VILLAGE OF THIENSVILLE
PLAN COMMISSION
AGENDA

DATE: Wednesday, June 10, 2020
LOCATION: Village of Thiensville
250 Elm Street

PRO HEALTH CHIROPRACTIC CLINIC SIGN PLAN

To: Thiensville Plan Commission

Plat Map

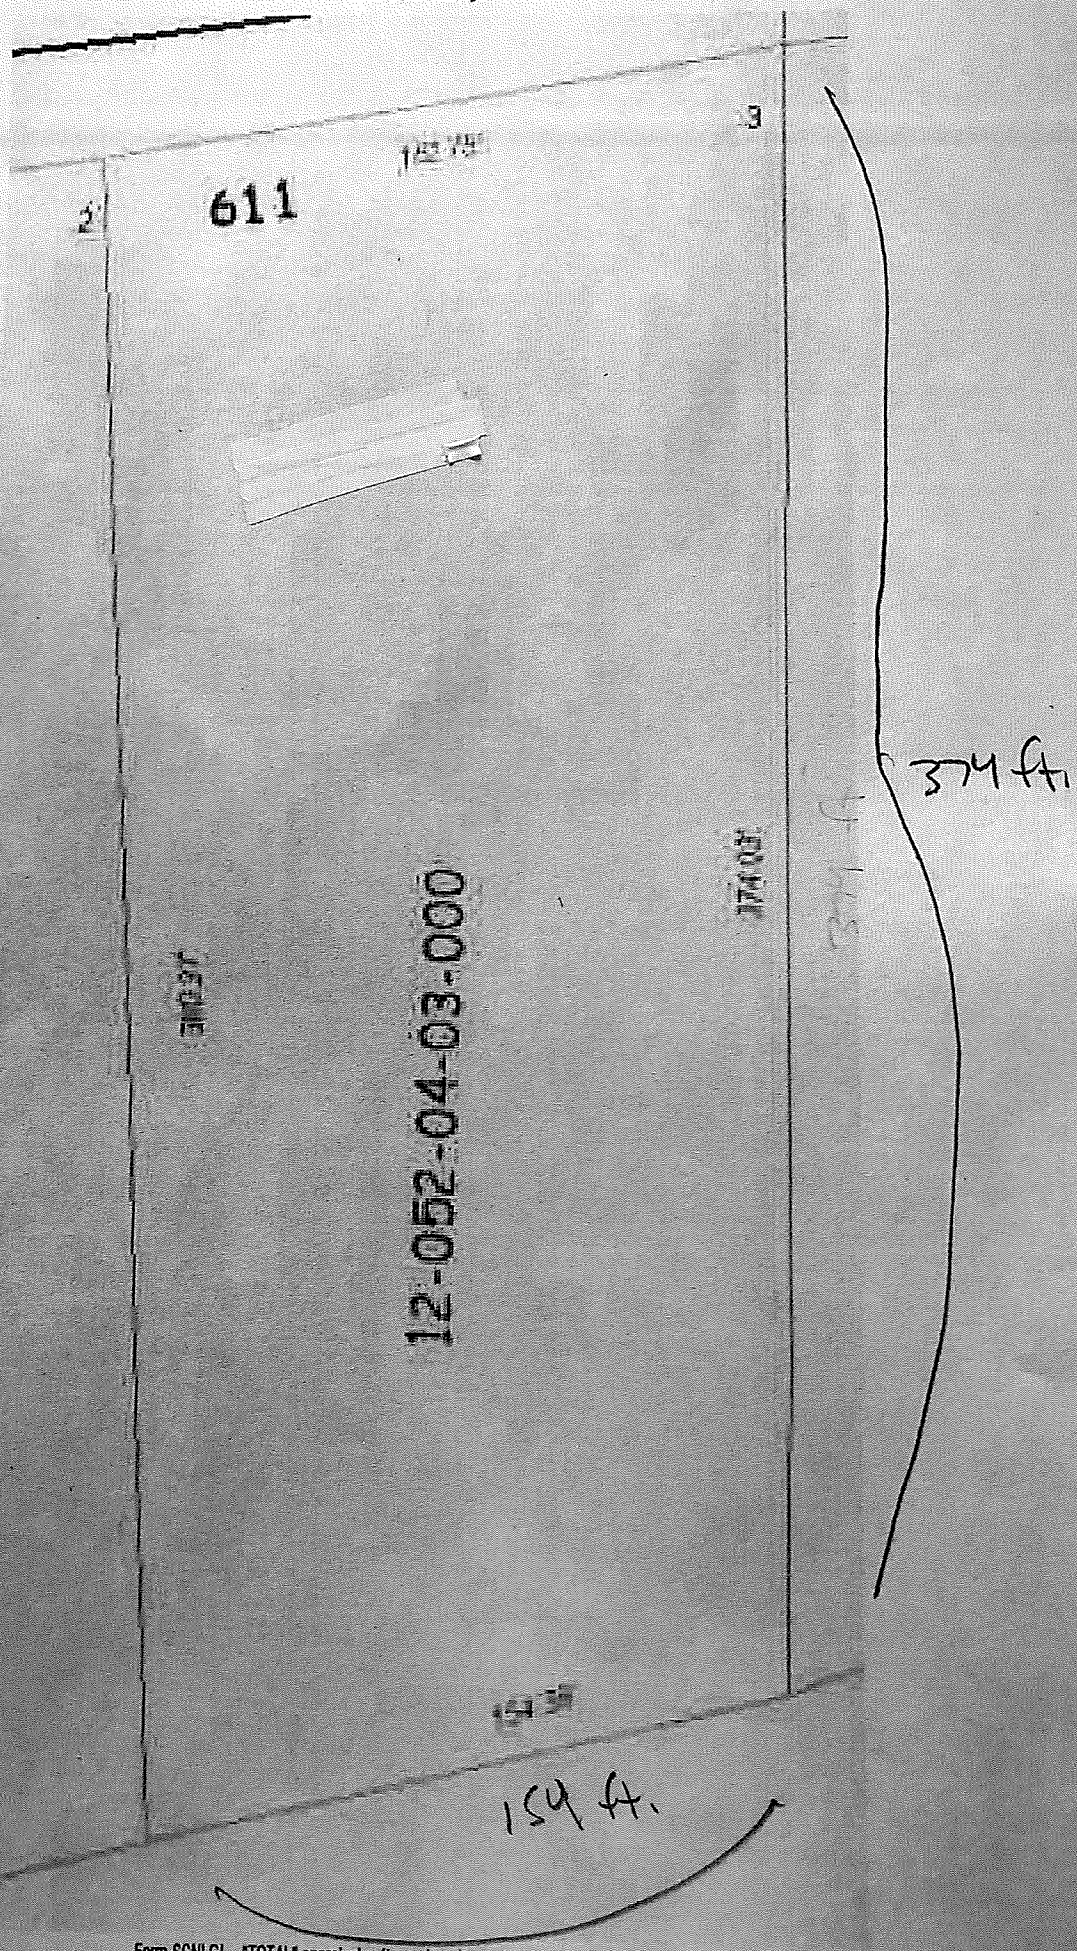
My review indicates full compliance with the dimensional requirements of the accessory structure section of the code. Since the plan does not show the specific location of the pool, I recommended that it be place closer to their home than any lot line. Since this is not a structure, a building permit is unnecessary.

NORTH WALL SIGN

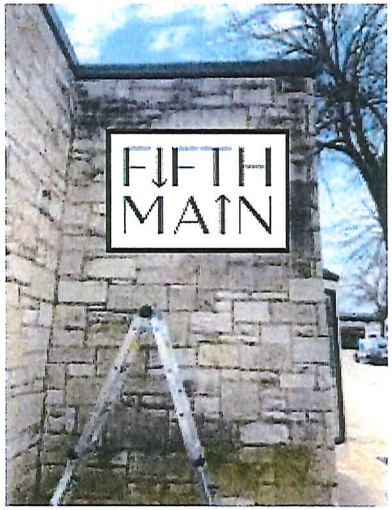
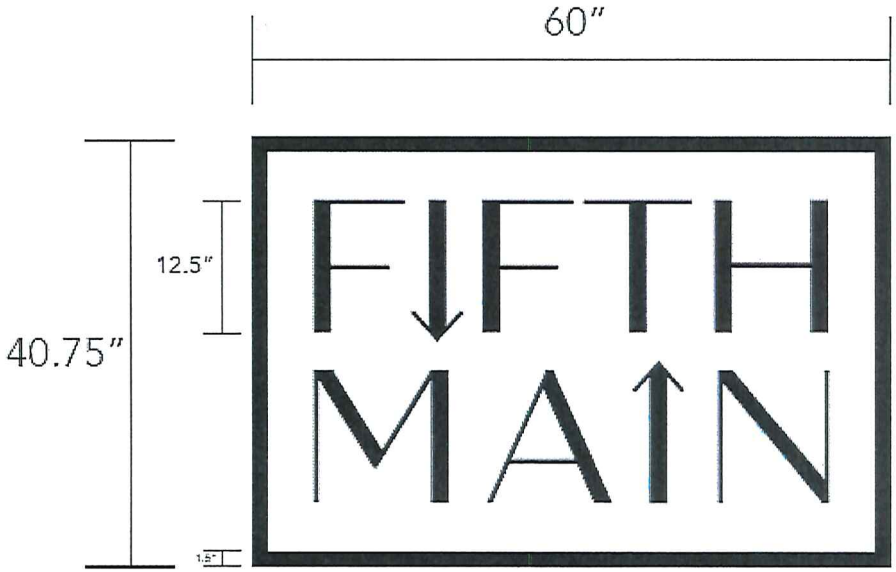
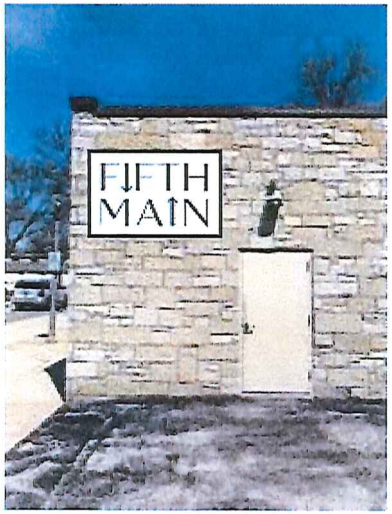
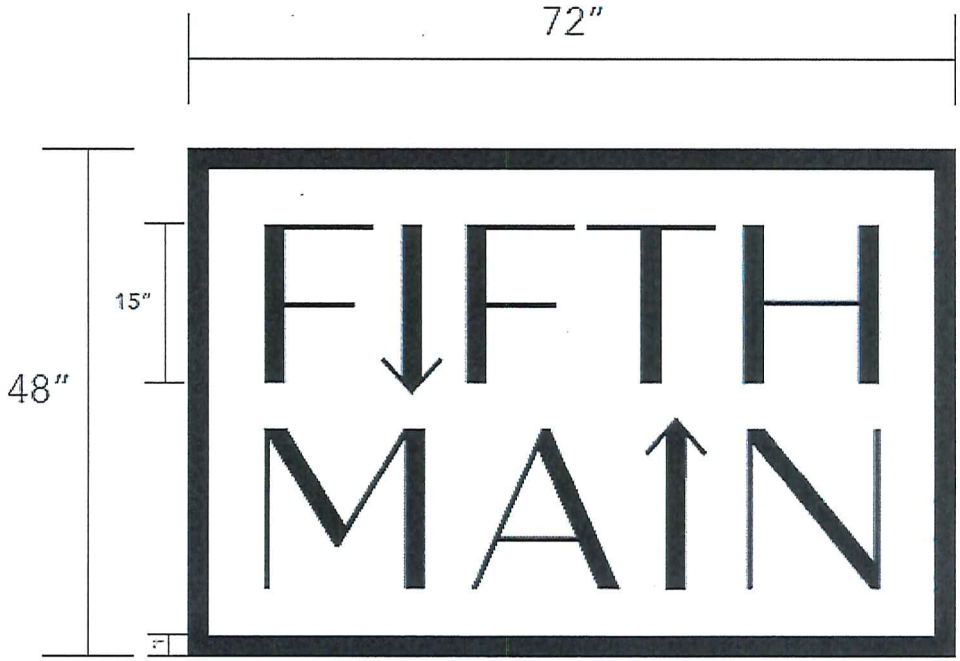
The two wall mounted signs measure 16.98 square feet and 24 square feet in size and because they are proposed for the side of the building, they are not code compliant as the code permits wall mounted signs on the front elevation only. Therefore, the applicant must seek a waiver for these two signs. Commissioners are reminded that you do have the authority to grant such a waiver under **Section 16.24 Variances** which states: **The Plan Commission may, in its judgement, waive or modify the provisions of this chapter where it would further the public interest.**

Proposed 24'x22' Det Garage As Shown.

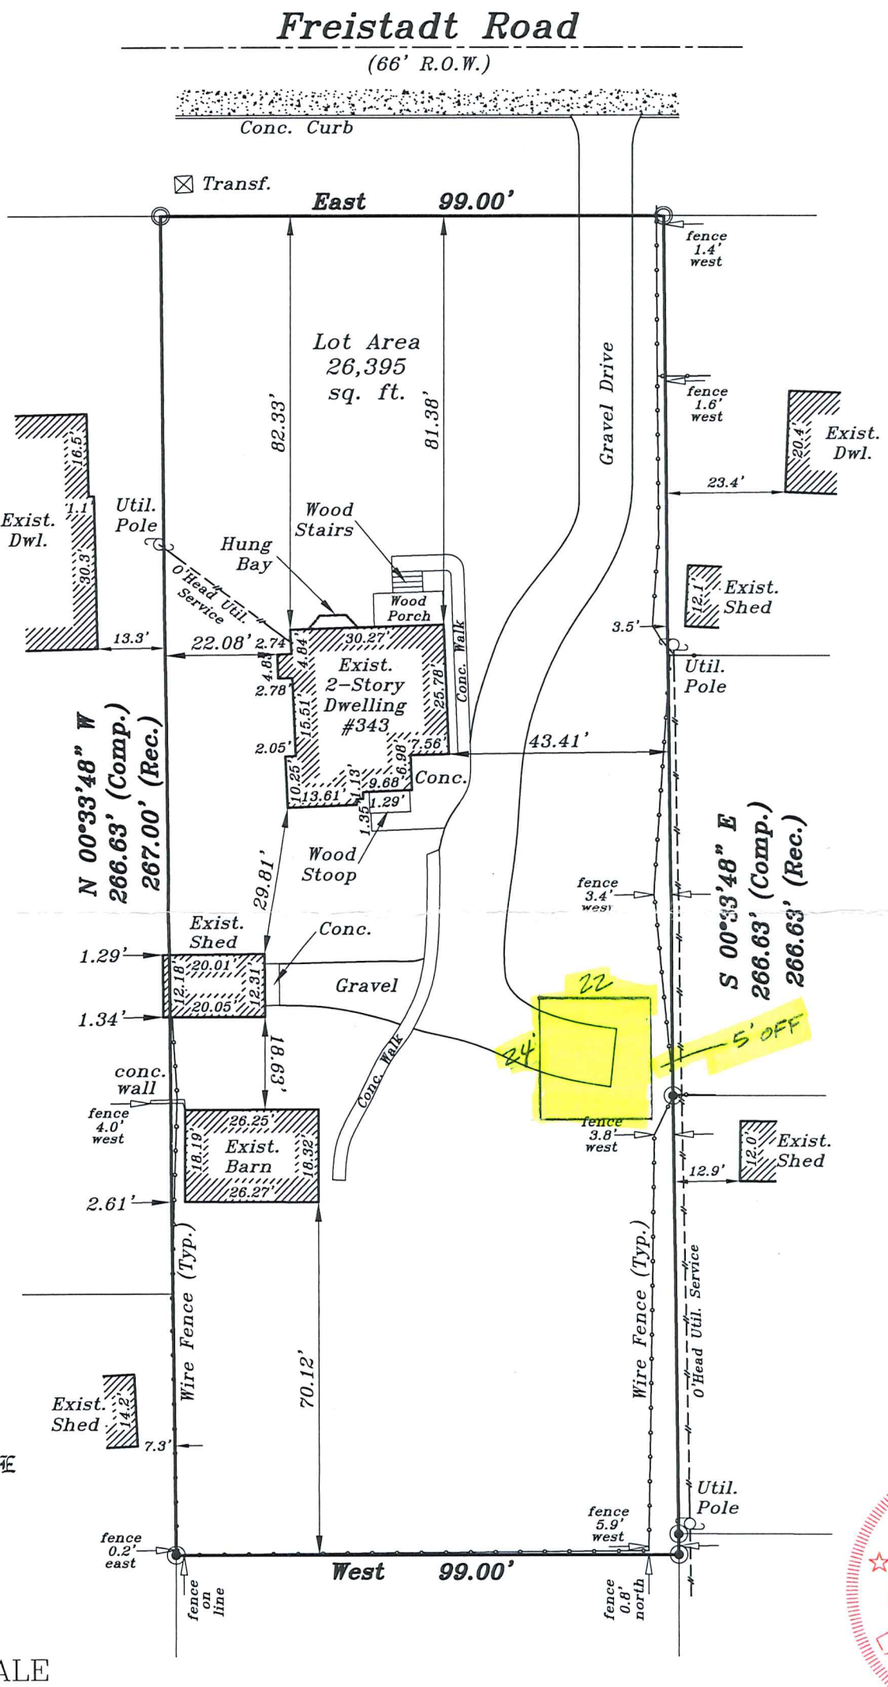
While the plans show two existing accessory buildings in the back yard, the applicant has indicated that the existing barn will be razed as part of this project. To be code compliant, the garage will need to meet the required 3-foot setback. Accordingly, staff recommends approval subject to the following:

- No building permit shall be issue for the garage until the razing permit to remove the garage is secured.
- The proposed garage shall be setback from the adjacent property line by 3'
- The applicant securing a building permit prior to construction.

Proposed 24'x22' Det Garage As Shown.

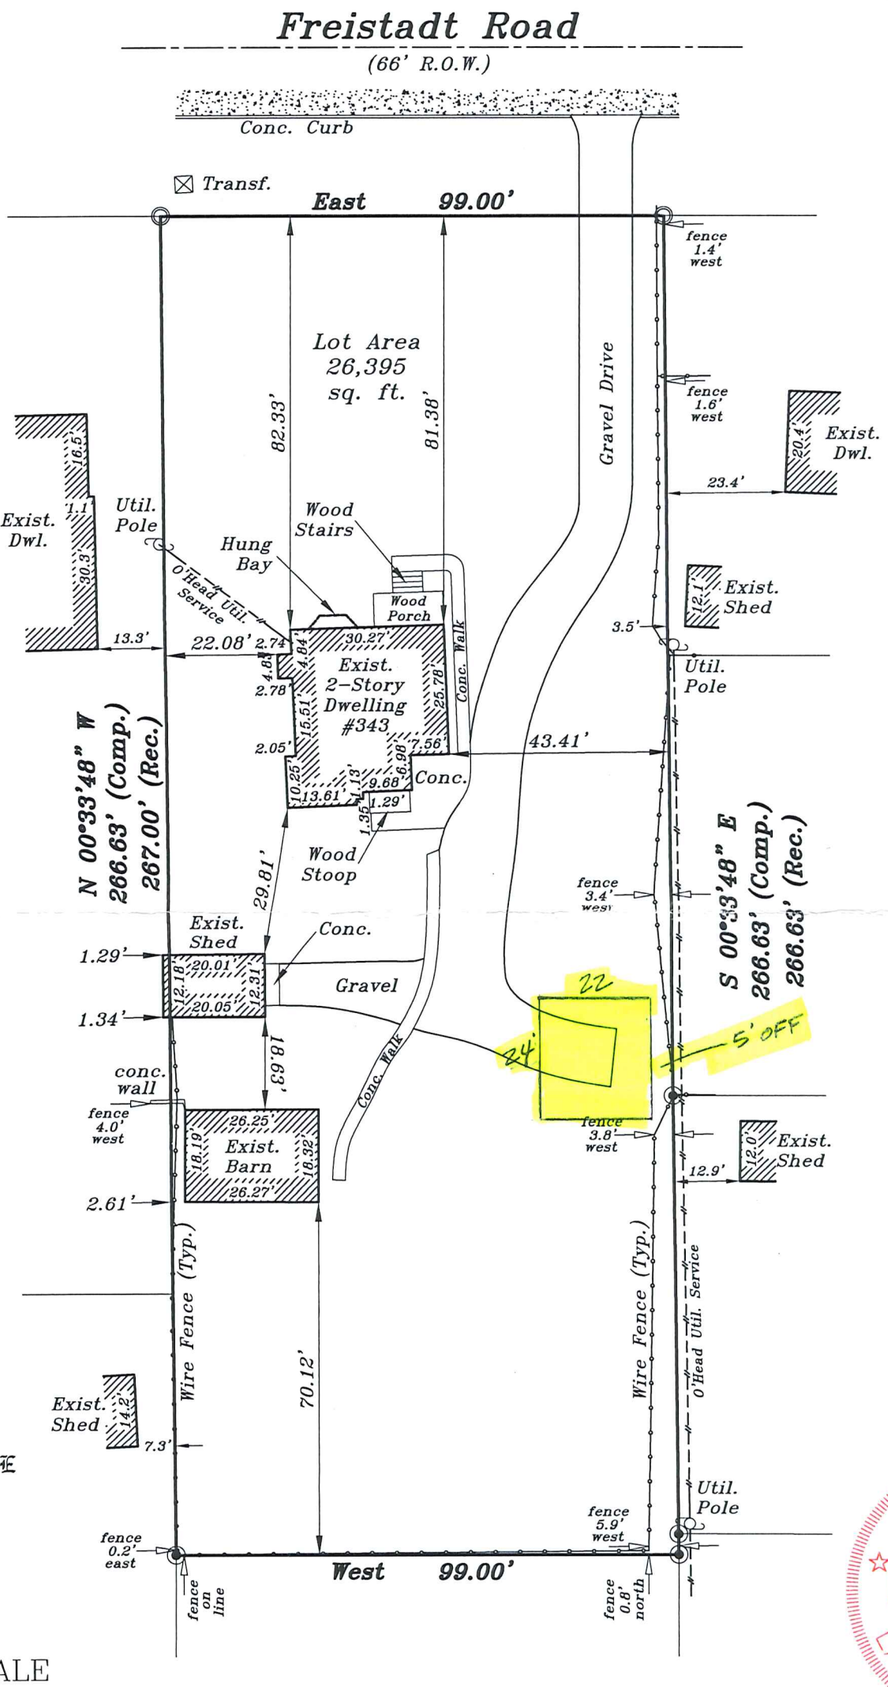
While the plans show two existing accessory buildings in the back yard, the applicant has indicated that the existing barn will be razed as part of this project. To be code compliant, the garage will need to meet the required 3-foot setback. Accordingly, staff recommends approval subject to the following:

- No building permit shall be issue for the garage until the razing permit to remove the garage is secured.
- The proposed garage shall be setback from the adjacent property line by 3'
- The applicant securing a building permit prior to construction.
